Boulder County Public Health OWTs Inspection Results

PERMIT TO INSTALL, CONSTRUCT, ALTER, OR REPAIR ONSITE WASTEWATER SYSTEM(S).

Permit Type: OWTS MAJOR REPAIR (FULL FEE)
Site Address 17503 HWY 7 Lyons, CO 80540
Legal Description (short) 323N72W

INSTALL SYSTEM PER VAN HORN ENGINEERING AND SURVEYING, PROJECT NO. 2016-04-16 DATED 6/22/16 AND STAMPED 6/27/16, AND REVISION DATED AND STAMPED ON 6/22/18, AND PER ALL BOULDER COUNTY PUBLIC HEALTH (BCPH) ONSITE WASTEWATER TREATMENT SYSTEM (OWTS) REGULATIONS. SYSTEM MUST BE INSTALLED IN THE AREA OF SOIL TEST PITS BY A CONTRACTOR LICENSED BY BCPH.

STANDARD GRAVEL AND PIPE DESIGN

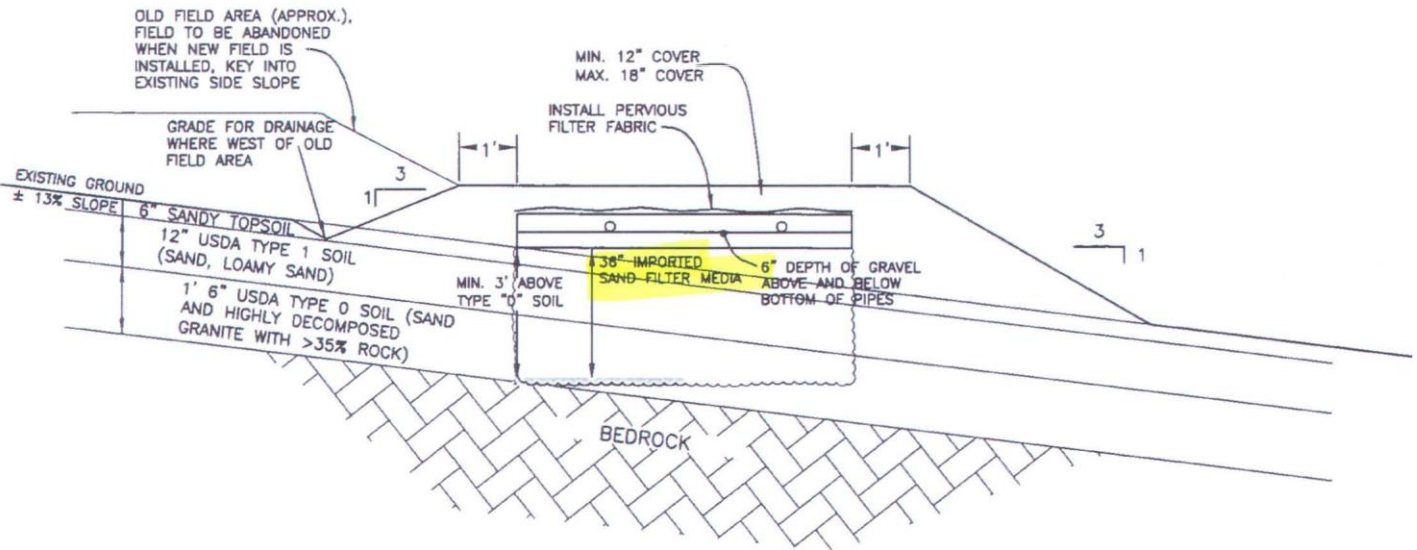
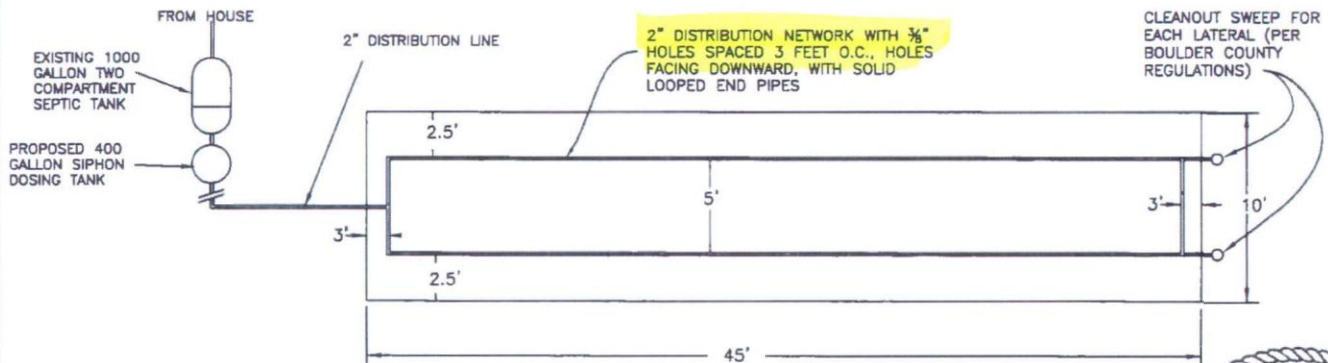
PER ENGINEER REVISION DATED 6/22/18, RIP AND REMOVE ALL EXISTING SOIL DOWN TO 3-FEET BELOW EXISTING GRADE AND REPLACE WITH ASTM-33 SAND APPROVED BY ENGINEER. INFILTRATIVE SURFACE (BOTTOM OF GRAVEL LAYER) MUST BE INSTALLED AT EXISTING GRADE. INSPECTION PORTS ACCESSIBLE FROM GRADE MUST BE INSTALLED AT THE TERMINAL END OF EACH DISTRIBUTION LINE AND MUST EXTEND DOWN TO INFILTRATIVE SURFACE. FLUSHING VALVES MUST BE INSTALLED AT THE END OF EACH DISTRIBUTION LINE AND BE ACCESSIBLE FROM GRADE. A MINIMUM 3:1 SLOPE MUST BE CONSTRUCTED TO ENGINEER'S SPECIFICATIONS ALONG ALL SIDES OF THE STA. FINAL GRADING MUST DIVERT SURFACE WATER RUNOFF AWAY FROM STA. MAINTAIN MINIMUM REQUIRED SETBACKS OF 10' TO PROPERTY LINES, 20' TO OCCUPIED BUILDINGS, 25' TO WATERLINES, 50' TO WATERWAYS, 100' TO ALL WELLS. CISTERN ON SITE IS NON-POTABLE - NO SETBACK.

4. THE EXISTING MATERIAL IS TO BE RIPPED AND 36" OF SAND FILTER MEDIA SHALL BE ADDED ON TOP OF THE RESTRICTIVE LAYER TO PROVIDE SUFFICIENT INFILTRATIVE DEPTH OF 36" TO THE RESTRICTIVE LAYER (IN THIS CASE THE RESTRICTIVE LAYER IS HIGHLY DECOMPOSED GRANITE - USDA TYPE 0 SOIL).

STANDARD GRAVEL AND PIPE DESIGN

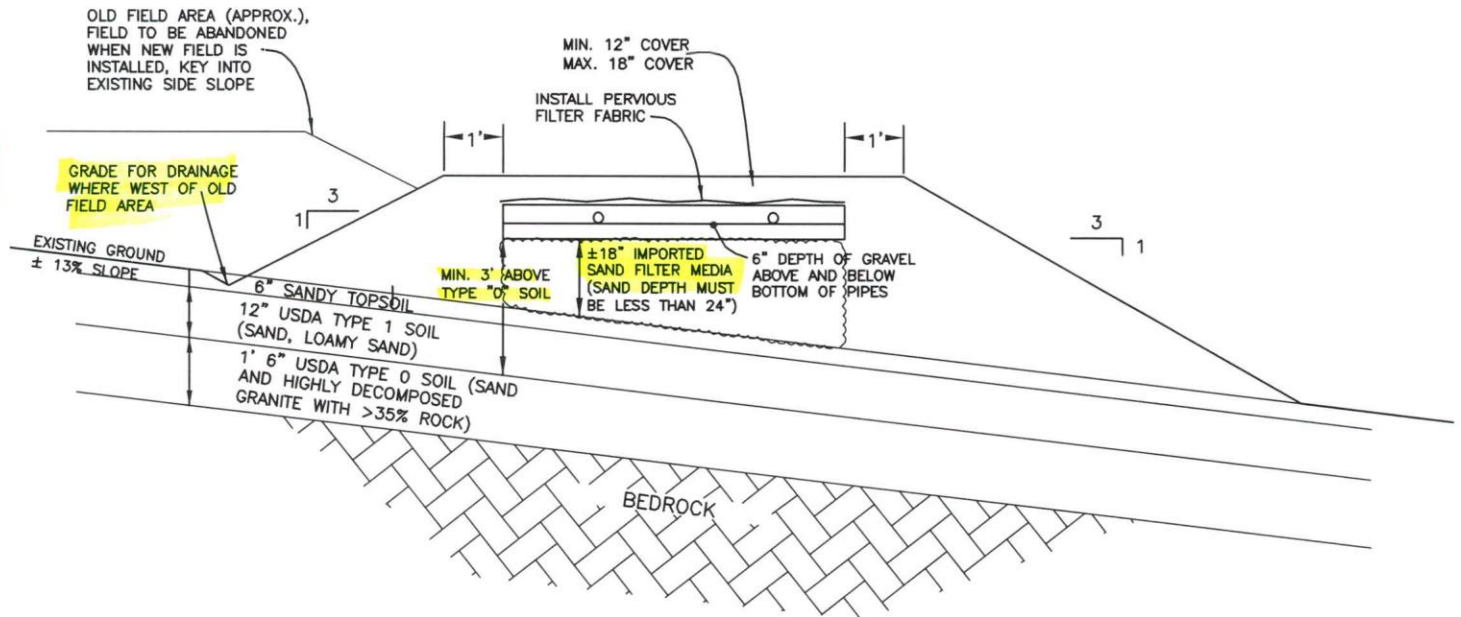
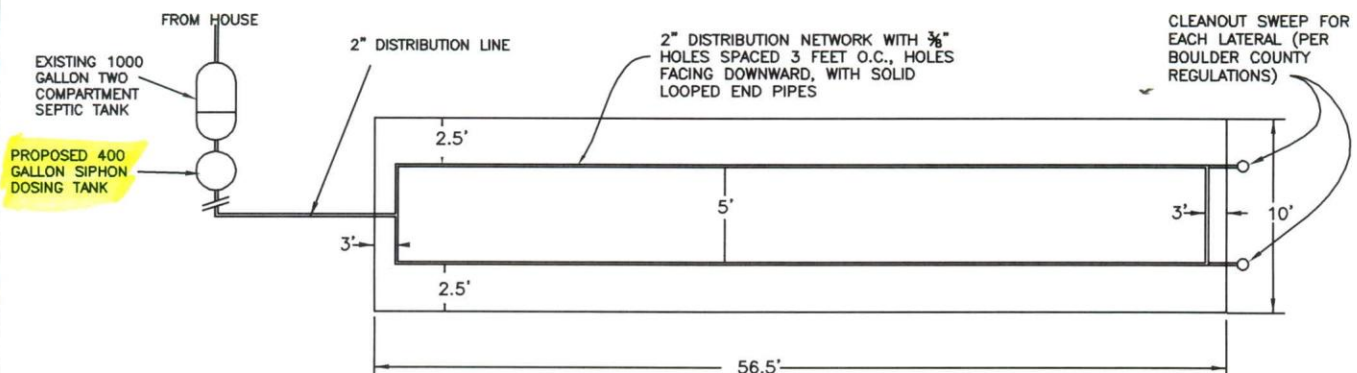
The Van Horn Design specifies to use the top 18" of existing Type 1 sandy soil, and to put another 18" of ASTM-33 concrete sand on top of that. (See the CROSS SECTION page of the design. Also see item #4 on the CONSTRUCTION AND MAINTENANCE NOTES page). So yes that is a BIG MOUND.

The regulations do require 3-feet of absorption material. They are using 18-inches of the soil that is there plus 18-inches of sand which equals 36-inches which is 3-feet.

Since the bedrock layer is at 3-feet down below existing grade, another option you may wish to discuss with Van Horn would be removing ALL OF THE EXISTING SOIL down to 3-feet below existing grade and replacing all of it with ASTM-33 sand. That way you would not need such a big mound and the gravel layer could be placed at existing grade. I don't know if this would cost less or not – you will have to ask Van Horn and the installers.

An important item for Van Horn to know: They DO NOT NEED AND EXTRA 2 FEET OF BUFFER MATERIAL UNDER THE 3-FEET OF SAND.

- That was required in 2016 when Van Horn wrote up this design – and that may be what they were trying to avoid by using less than 2-feet of sand.
- This regulation changed at the state level in June 2017 and since this design was submitted to BCPH AFTER that date, we will waive that requirement.

If, after discussing this with Van Horn, you wish to have them redesign this system, please have them submit a redesign to me and I will rewrite and reissue the permit.
